# UNITED STATES PATENT AND TRADEMARK OFFICE

APPLICATION NO.	FILING DATE	FIRST NAMED INVENTOR	ATTORNEY DOCKET NO.	CONFIRMATION NO.
10/824,658	04/15/2004	Joseph Hess	NOVAP0012	7721
24203	7590	03/15/2006	EXAMINER	
GRIFFIN & SZIPL, PC SUITE PH-1 2300 NINTH STREET, SOUTH ARLINGTON, VA 22204			MARTIN, LAURA E	
			ART UNIT	PAPER NUMBER
			2853

<b>Office Action Summary</b>	Application No. 10/824,658	Applicant(s) HESS ET AL.	
	Examiner Laura E. Martin	Art Unit 2853

## **DETAILED ACTION**

Figure 3a

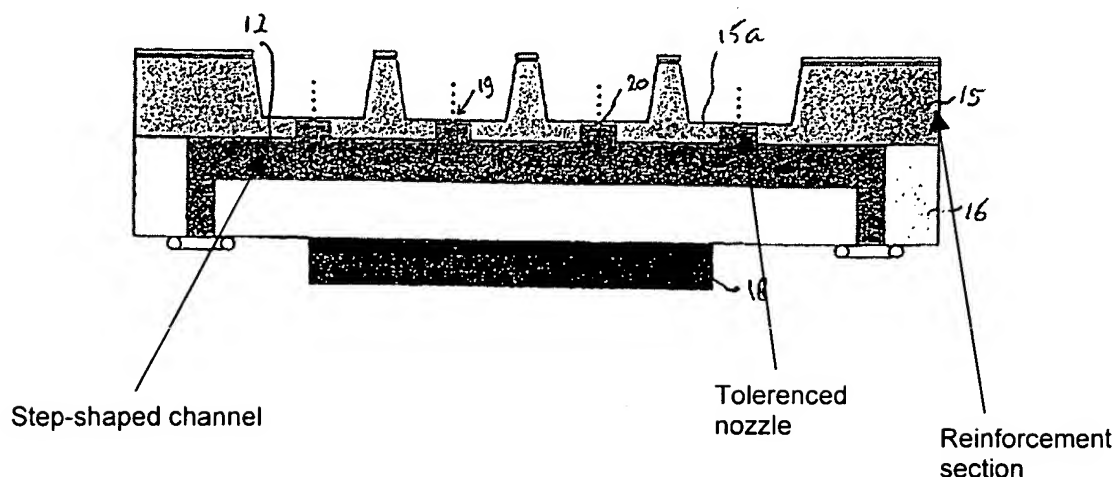
As per claim 1, Hess et al. teaches a nozzle body for a liquid droplet (figures 3a, 3b, and 3c) comprising: a first substrate in which a space is formed (figure 3a, element 16), a second substrate having at least one nozzle membrane section (figure 3a, element 15) and reinforcement section (figure 3a, element 15), wherein said first and second substrates are arranged such to enclose the space [0027], wherein each of said nozzle membrane sections comprises a high density array of outlet nozzles and output channels (figure 3a, element 20) that connect said enclosed space with each of said

outlet nozzles, said outlet nozzles and said output channels having a tightly toleranced, straight, non-tapered shape, wherein said second substrate has a top surface in which at least one cavity is formed (figure 3a, element 15a) so as to provide the nozzle membrane section corresponding to the bottom of said cavity with surrounding reinforcement sections, and a bottom surface adjacent to and enclosing said space thus forming a chamber for containing said liquid substance [0027-0029], wherein each said nozzle output channel is step shaped [0018] with a wider portion being adjacent said space and a thinner portion containing a protrusion section protruding beyond the top surface of said nozzle membrane section of said second substrate (figure 3a, element 15) such that the exterior side wall of the protrusion section of said output channel is a substantially straight angle with respect to the top surface of said nozzle membrane section of said second substrate (figure 3a, element 12). Examiner notes that the preamble does not hold weight to the claim rejection.

As per claim 9, Hess et al. teaches a liquid droplet spray device comprising a nozzle body (figure 3a) and a vibrating element disposed to vibrate liquid in said space so as to eject said liquid substance as a spray through the outlet nozzles (figure 3a, element 18; [0033]).
